**STATE OF TENNESSEE
DEPARTMENT OF TRANSPORTATION
DESIGN DIVISION**

INSTRUCTIONAL BULLETIN NO. 14-05

Regarding Revised Standard Drawings

Effective for the August 29th Letting (June 18th turn-in), the following Standard Drawings are revised and Section V of the Design Guidelines is revised for this update.

STANDARD DETAILS FOR FLEXIBLE PIPE INSTALLATION

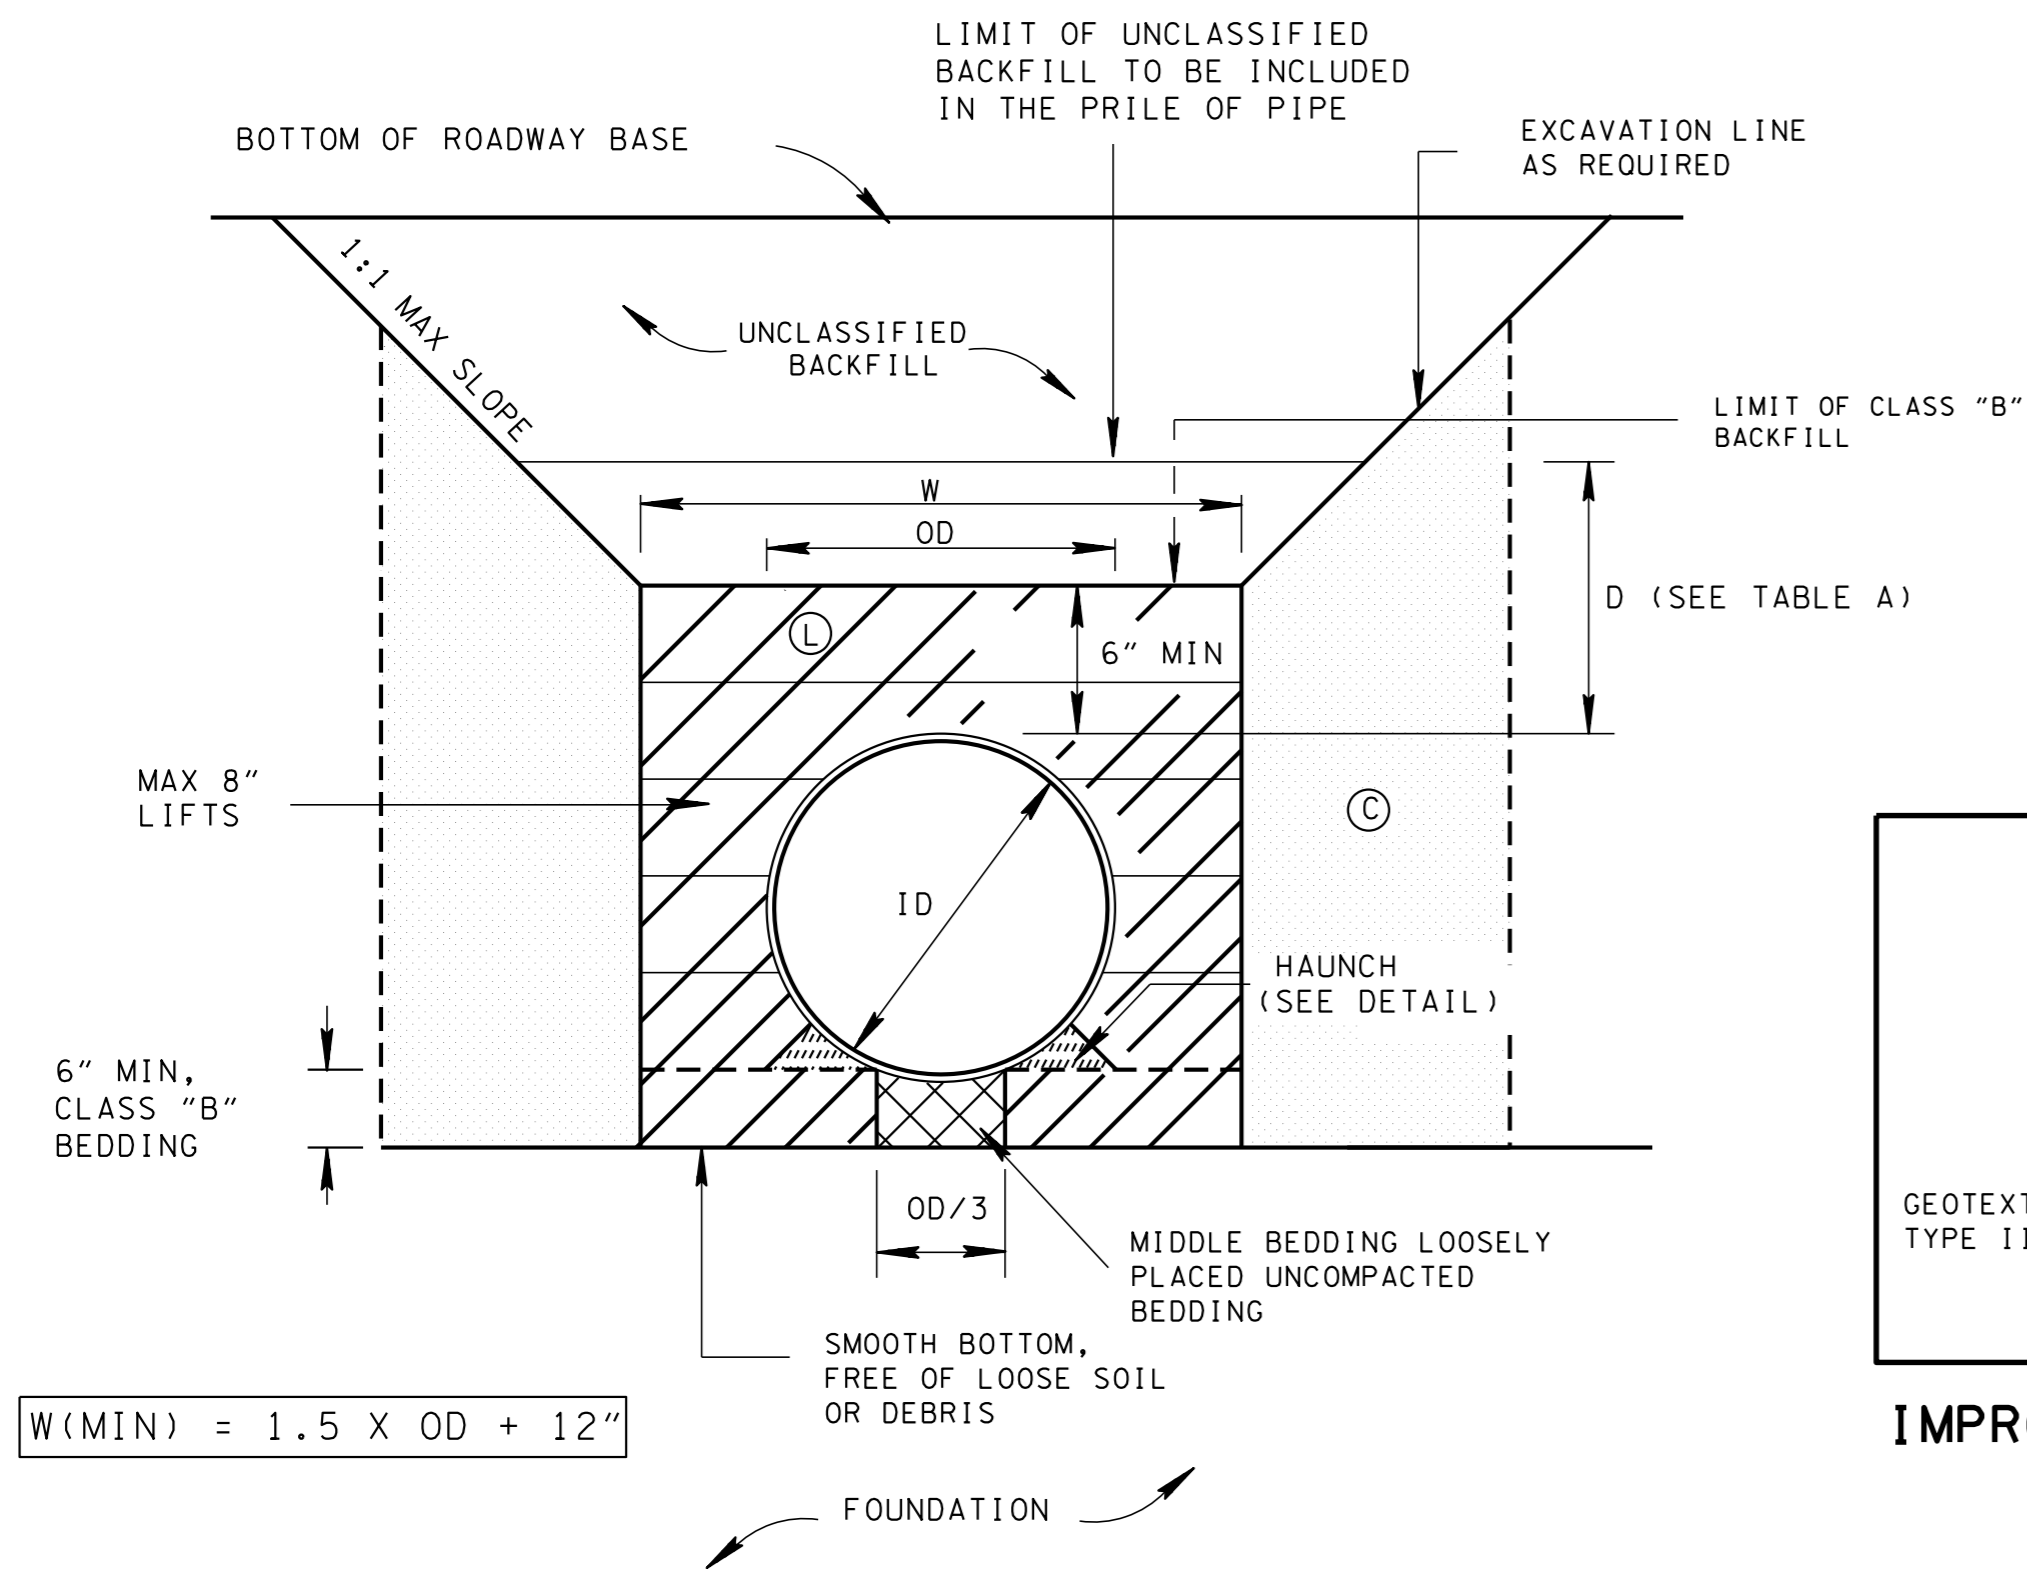
- REV. 7-12-07: REVISED GENERAL NOTE (L).
- REV. 6-1-09: REVISED GENERAL NOTE (I) AND TITLE NAME. ADDED GENERAL NOTE (L).
- REV.2-1-12: REVISED DRAWING NAME ADDED EFF DETAIL. REVISED GENERAL NOTES AND TABLE. ADDED MINIMUM COVER TABLE.
- REV. 8-21-12: REVISED GENERAL NOTES. CHANGED BACKFILL MATERIAL.
- REV. 1-2-13: REVISED TRENCH AND ADDED FILL DETAIL.
- REV. 1-29-14: ADDED PP. RELETTERED AND REVISED NOTES.

FOOTING DETAILS FOR OVERHEAD SIGN STRUCTURE 51" MEDIAN BARRIER WALL

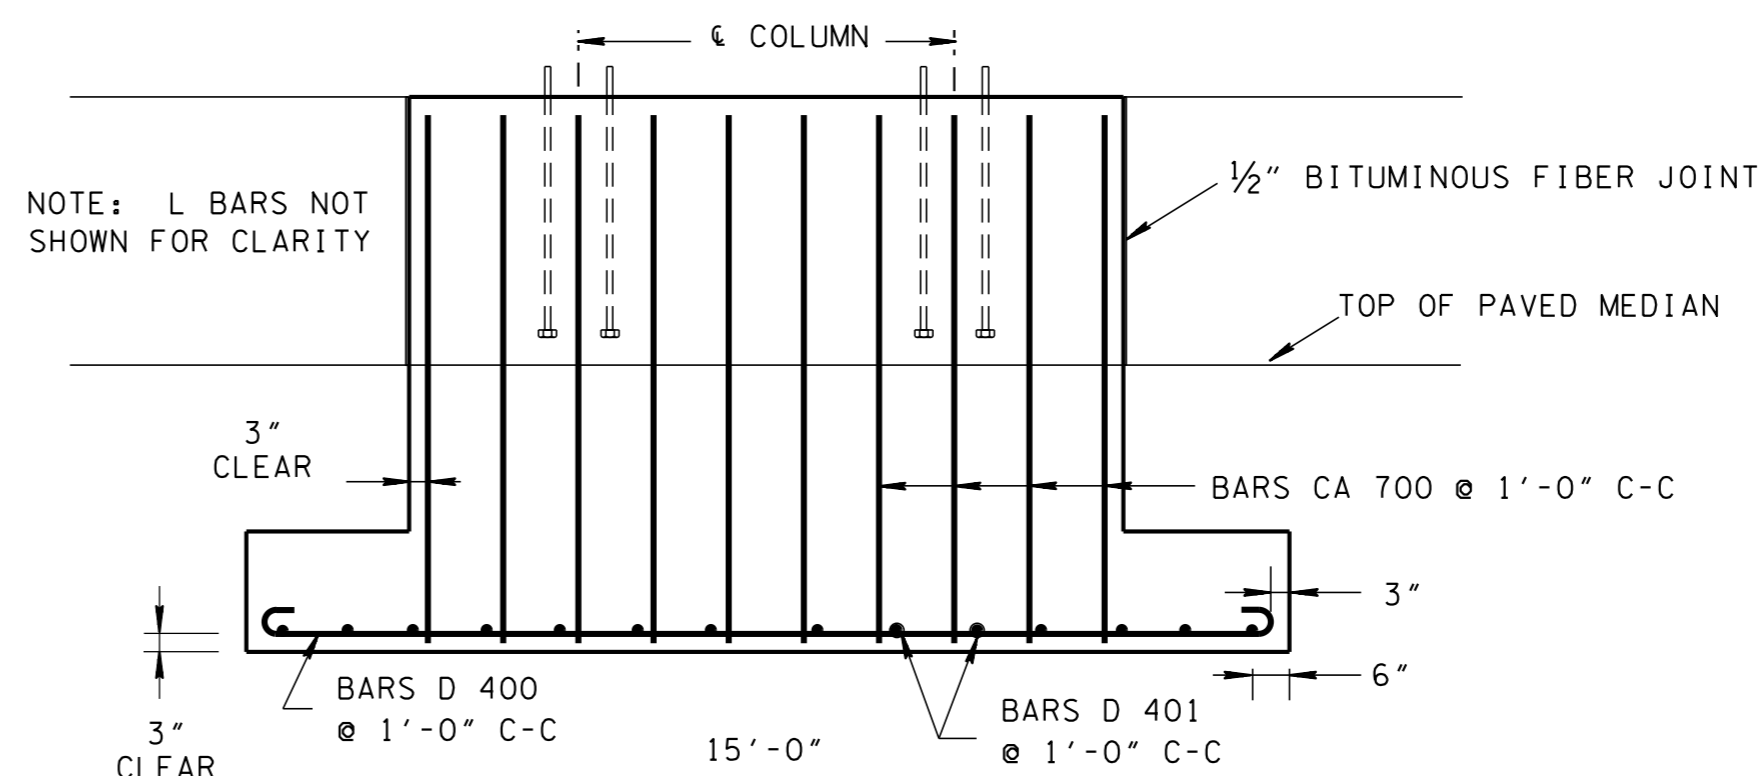
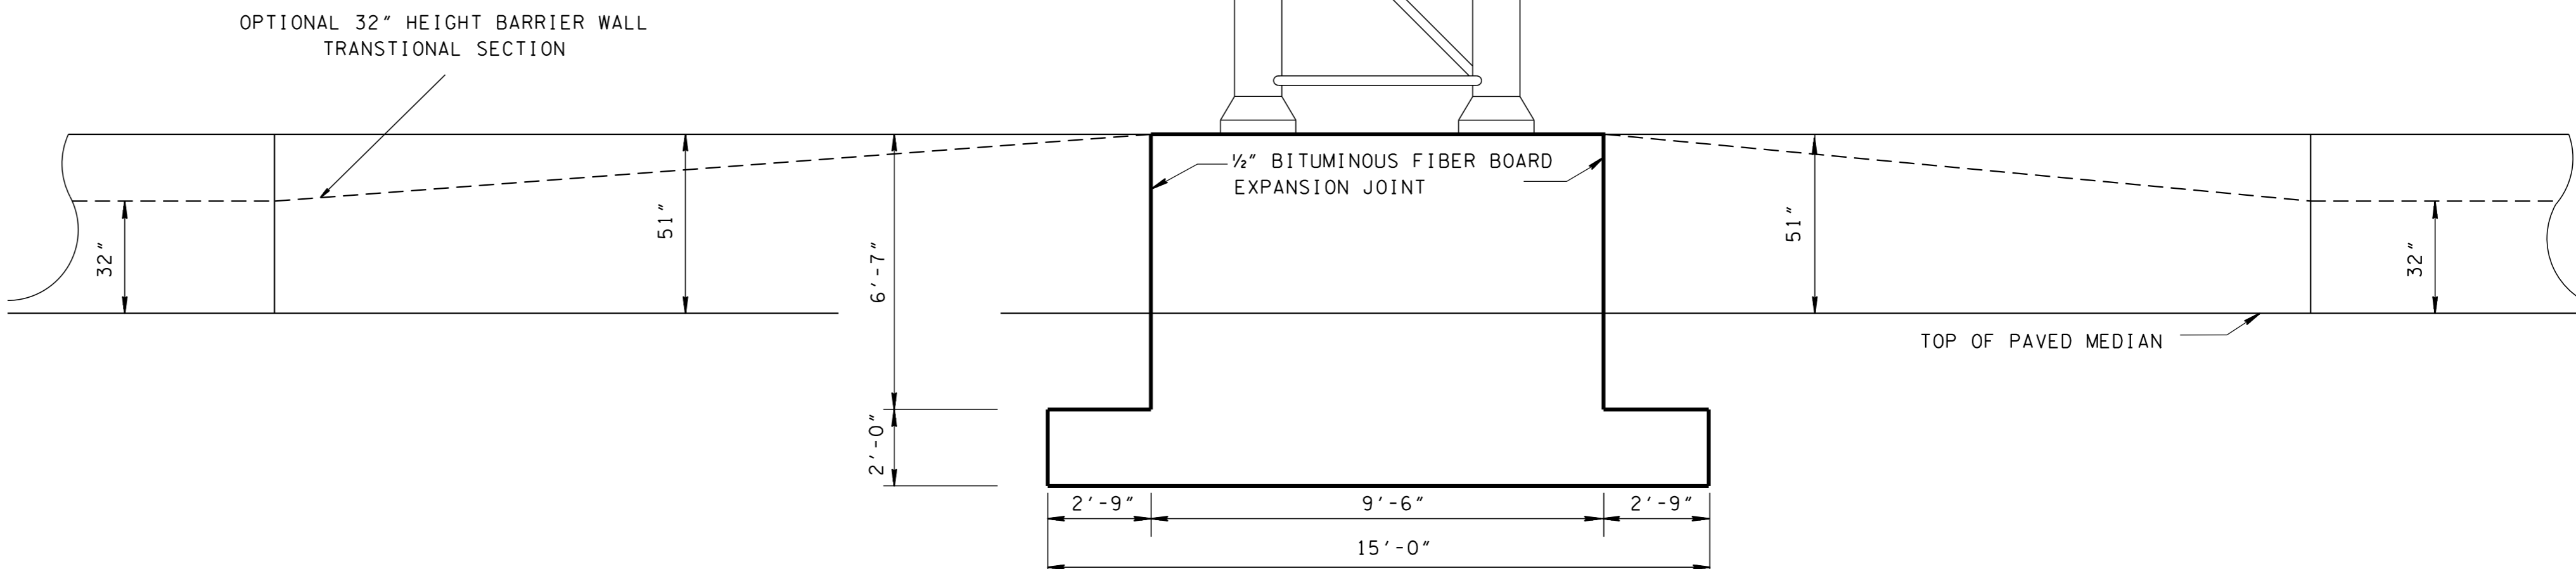
REV. 12-4-13: CHANGED ANCHOR BOLTS TO THREADED. ADDED BEARING AREA TABLE.
